**Re: Rocky Ford South Pit, Permit No. M-1977-222
Corrective Action Due Date for Problems Cited in May 08, 2014 Inspection Report
30-day Extension Request Approved**

COLORADO DIVISION OF RECLAMATION, MINING AND SAFETY
MINERALS PROGRAM INSPECTION REPORT
PHONE: (303) 866-3567

MINE NAME: Rocky Ford South Pit	MINE/PROSPECTING ID#: M-1977-222	MINERAL: Sand and gravel	COUNTY: Otero
INSPECTION TYPE: Monitoring	INSPECTOR(S): Amy Eschberger	INSP. DATE: May 8, 2014	INSP. TIME: 11:45
OPERATOR: ALL-RITE PAVING & REDI-MIX, INC.	OPERATOR REPRESENTATIVE: Herb Pearson	TYPE OF OPERATION: 112c - Construction Regular Operation

2011-2012
Rocky Ford South Pit
Permit M-1977-222

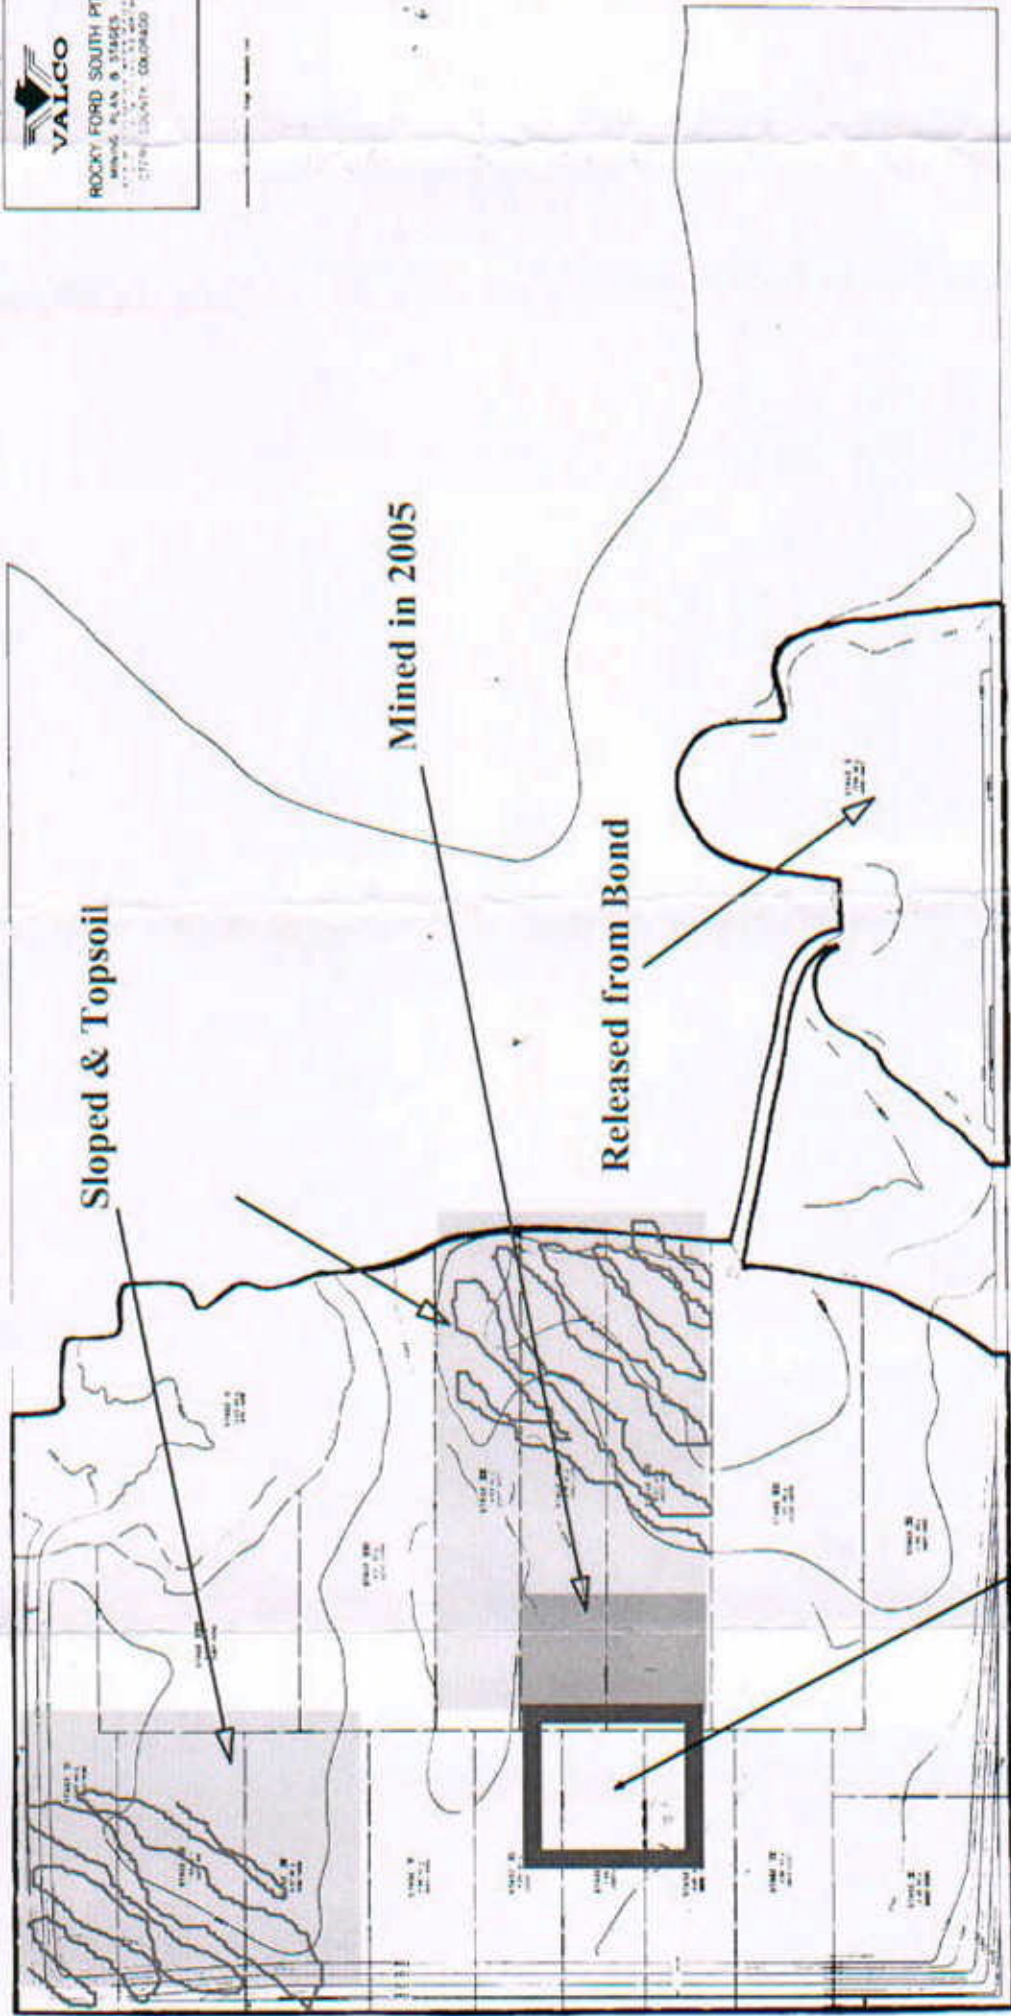
PROBLEM/POSSIBLE VIOLATION: Problem: The Annual Report and Map received on December 20, 2013 contain inaccurate information about the site. This is a problem for failure to submit accurate information in the Annual Report and Map as required by Rule 34-32.5-116(3)(a).

This site is accessed by a 20 foot wide gravel road that runs east from Co Rd 18, entering the northwestern portion of the permit area. This access road runs straight through the site and continues eastward, turning into Co Rd CC 5/10. An additional haul road of the same width runs approximately 900 feet southeast off of the main access road into the active pit area. A truck scale is located just north of the main access road (Photo 1) on a looped dirt road approximately 800 feet long and 20 feet wide. Based on the map provided in the Annual Report received on 12/20/2013 (enclosed), this scale road is located outside of the permit boundary. However, after further review, the Division has determined that the approved permit boundary includes the area with the scale road, and that information provided in the last Annual Report and Map is inaccurate. **This is cited as a Possible Problem for failure to submit an accurate Annual Report and Map as required by Rule 34-32.5-116(3)(a), and will require corrective action (see page 1).**

CORRECTIVE ACTIONS: The operator shall submit an Annual Report and Map that accurately describes current conditions at the site. The operator shall submit these documents by the corrective action date.

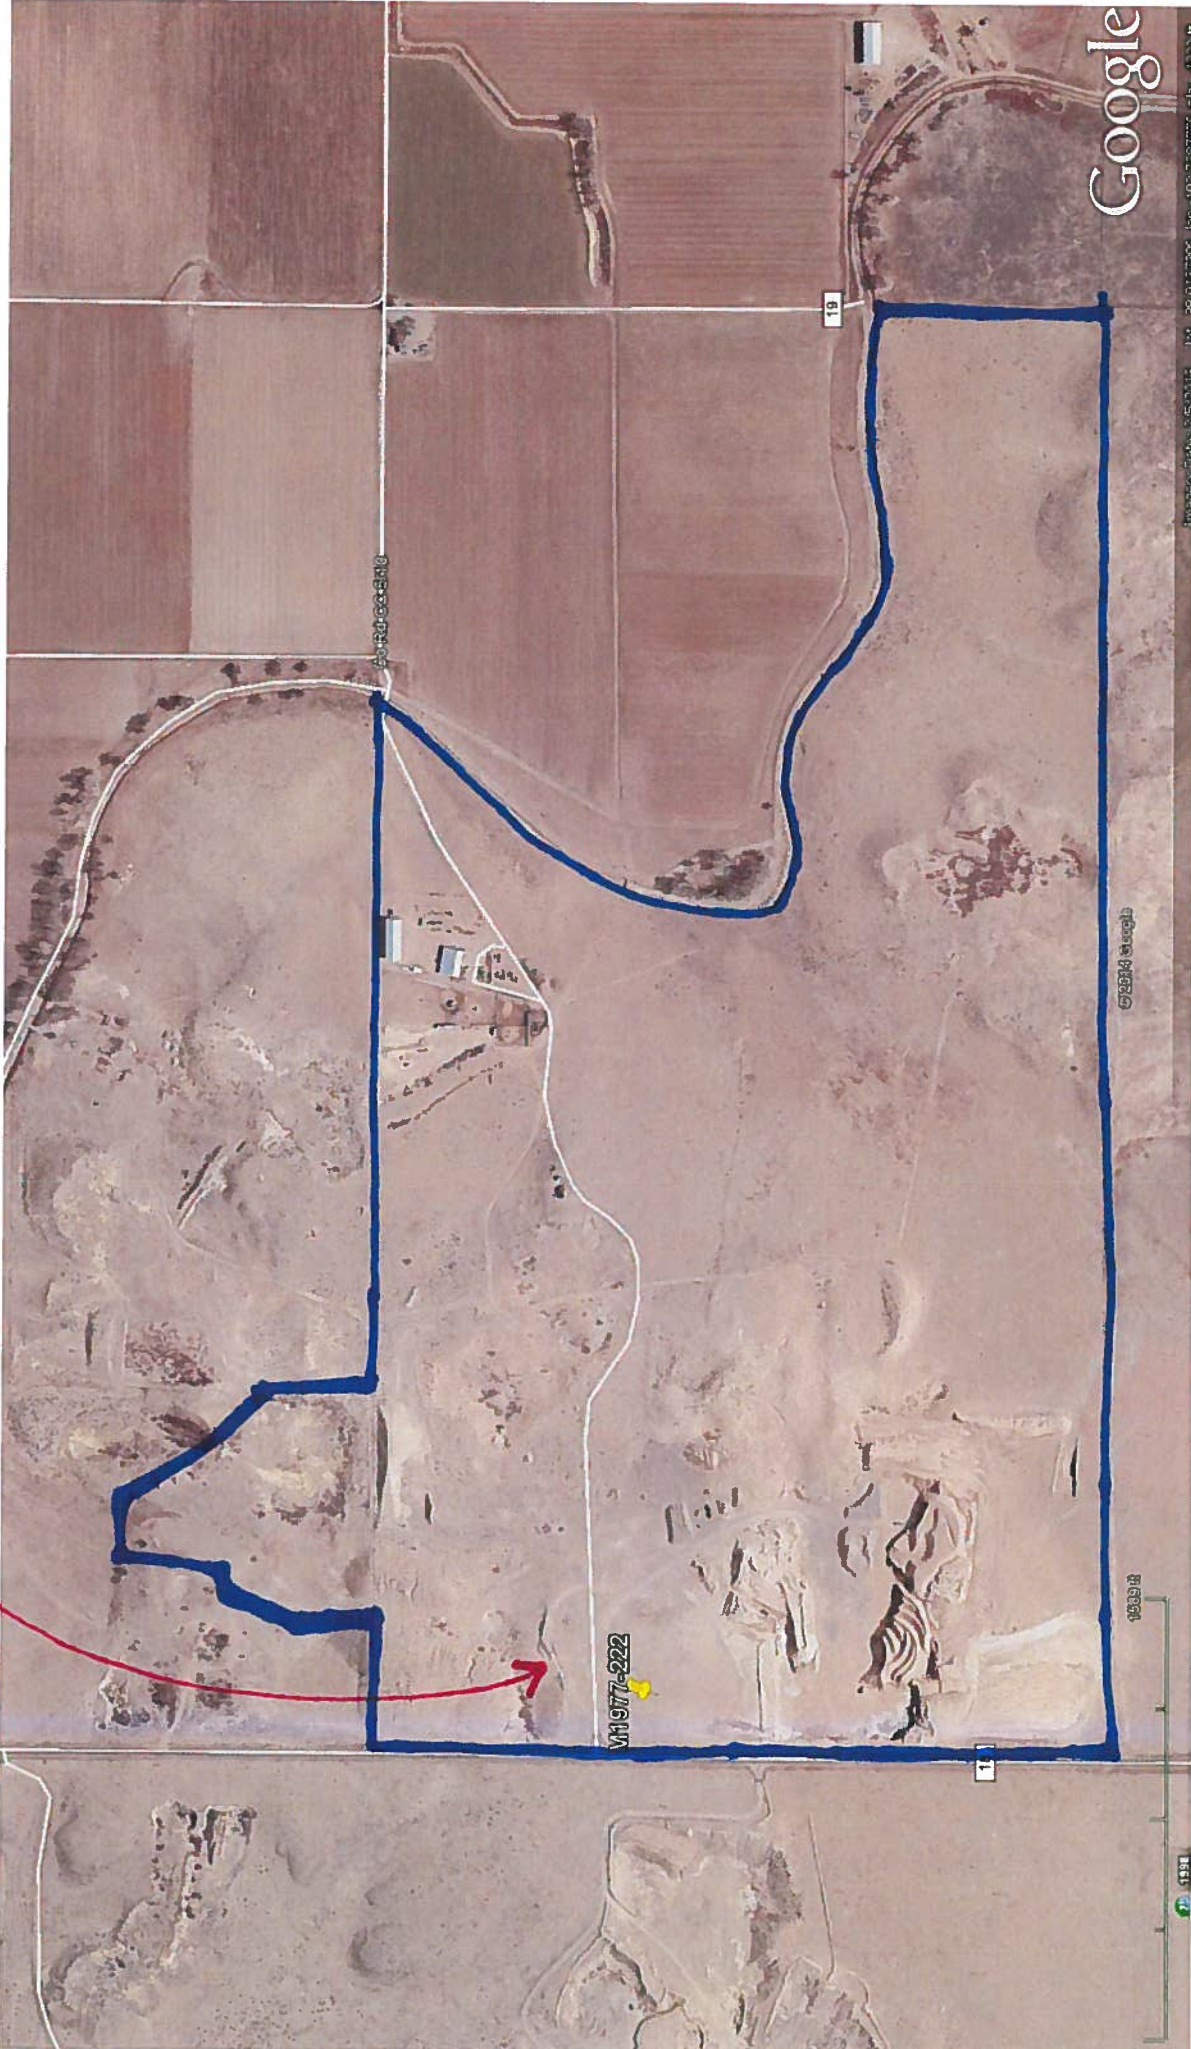
The map provided in the Annual Report received on 01/12/2006 (enclosed) appears to be the last map submitted that accurately displays the approved permit boundary for this site. The Operator will need to provide an updated map that shows the approved permit boundary and accurately displays the current layout of the site, including the scale, roads, excavation areas, and stockpile locations. As a reference, a Google Earth image of the site showing the approximate permit boundary according to Division records is enclosed with this report. This image shall only be used as a reference.
